Bulletin No: B407CRM155-0
 Release Date: April 3, 2008
 Effective Date: April 3, 2008
 Supersedes: N / A
 Completion Date: June 3, 2008
 Page: 1 of 3

SERVICE BULLETIN

Ride Name: PHARAOH'S FURY

Lap Bar Mounting Bolt Installation and Inspection

Installation Detail of LOCKING WASHER SET

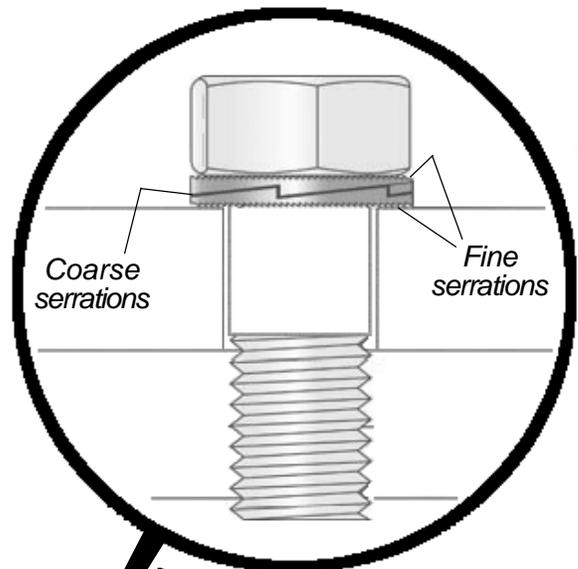
These washers must be installed in pairs. Make sure the coarse serrations of the two washers are mated with each other as shown. The fine serrations must be against the capscrew head and the mounting base.

*Discard existing capscrew. Replace with new
Hex Head Capscrew - 3/8-16 x 2-3/4"
(part number 60768000)
Tighten to 19 to 24 ft-lbs.*

*Discard existing split lockwasher.
Replace with LOCKING WASHER SET,
which consists of two special washers,
installed exactly as shown in the detail
(part number 228538803)*

*Inspect threads for
damage inside lap
bar mount*
